05/21/04 - ADDENDUM CHANGES

See RFI # 074  
Repair Clearance for T4 Rail.  
7/1/04

**TRAFFIC RAIL**  
(STEEL)

**TYPE T4(S) (MOD) B**

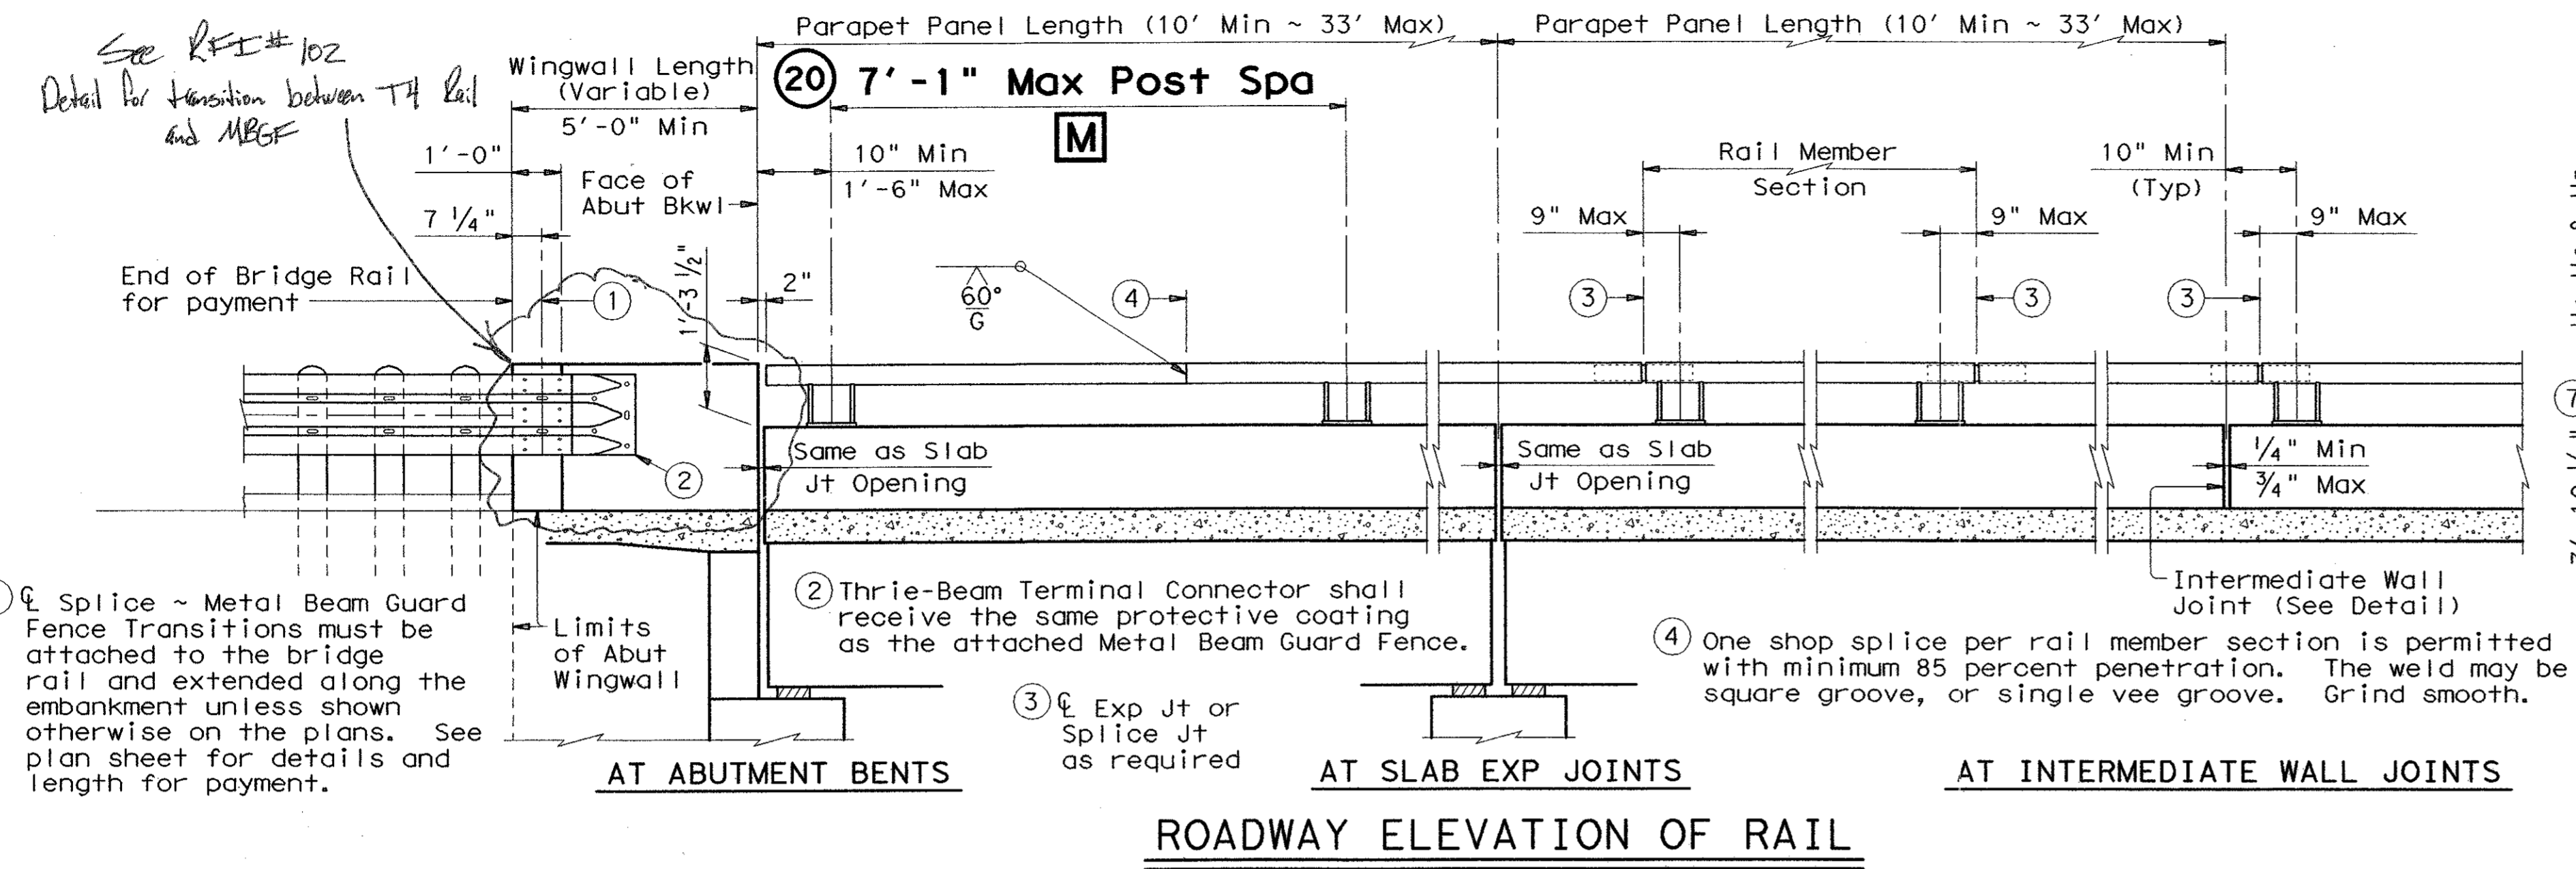
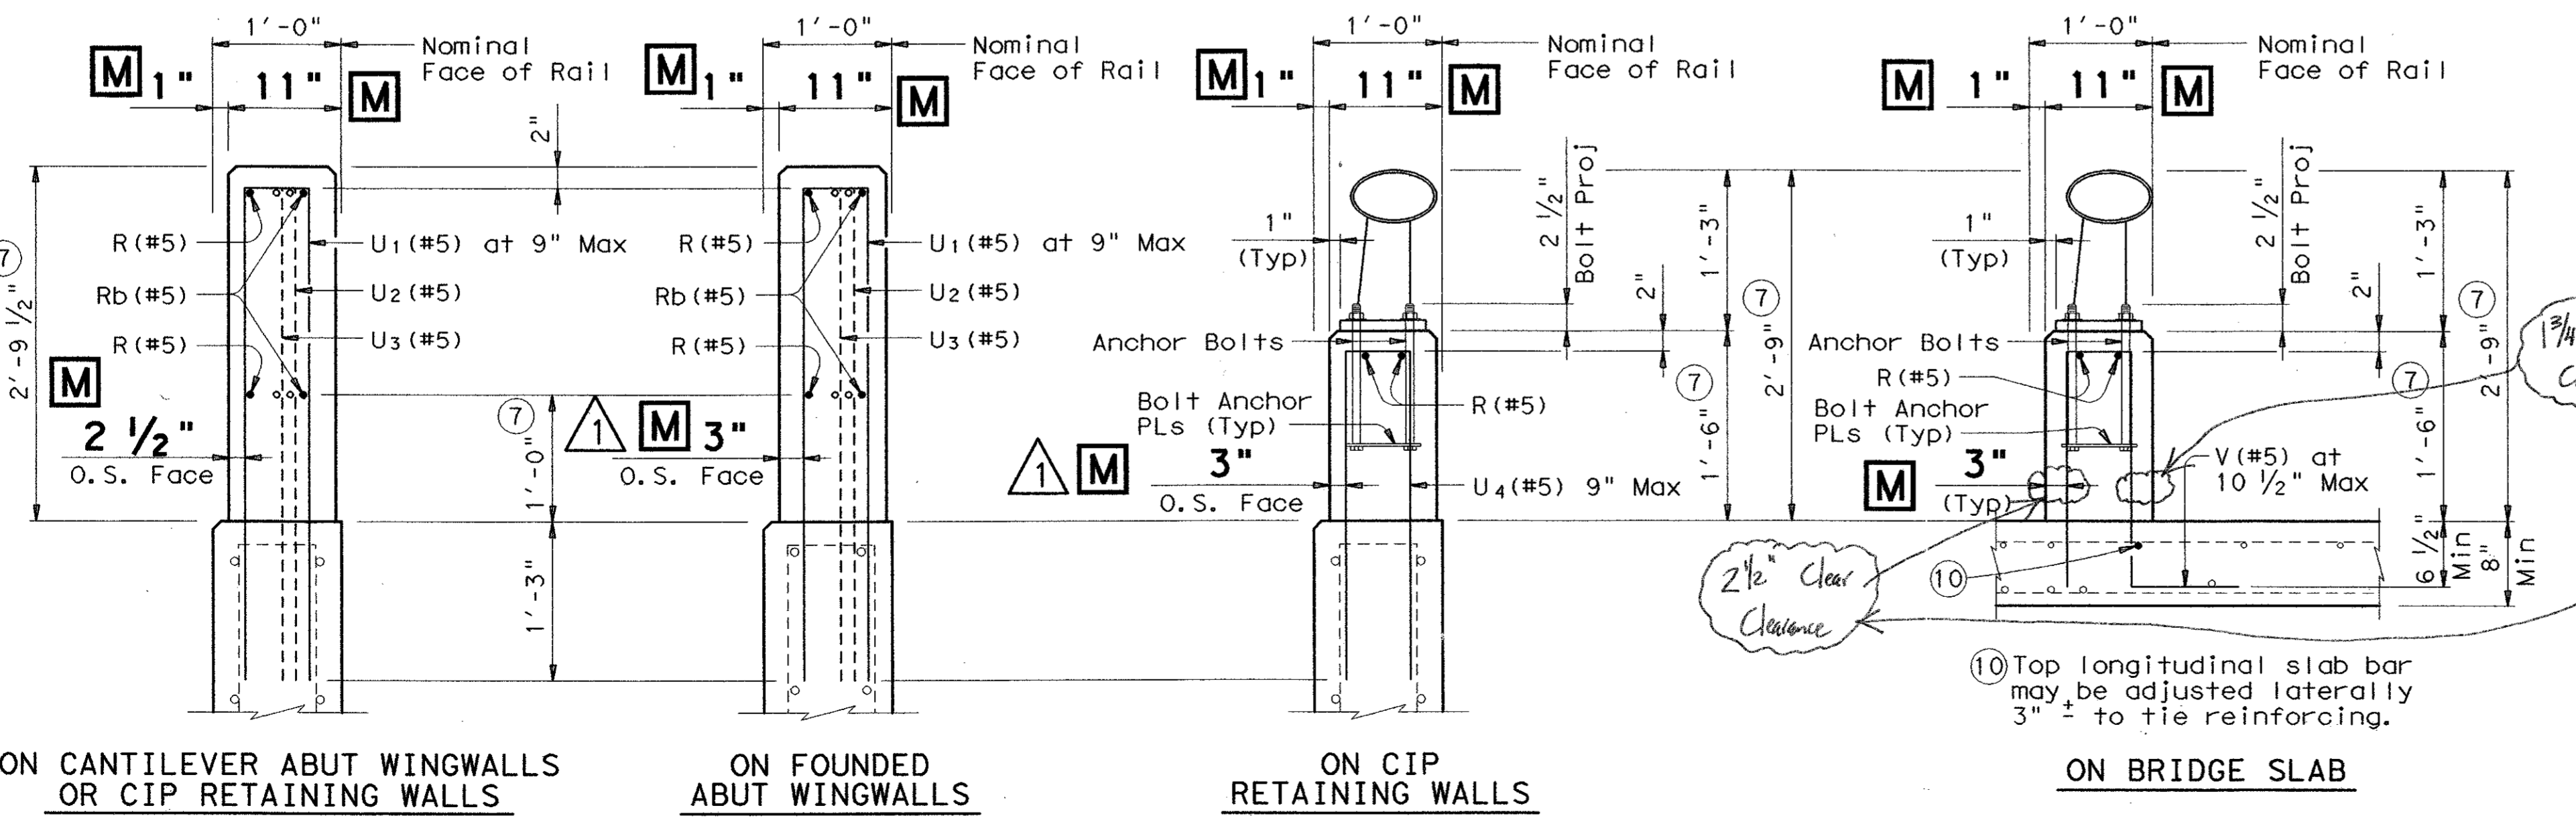
**M** MODIFIED ITEMS
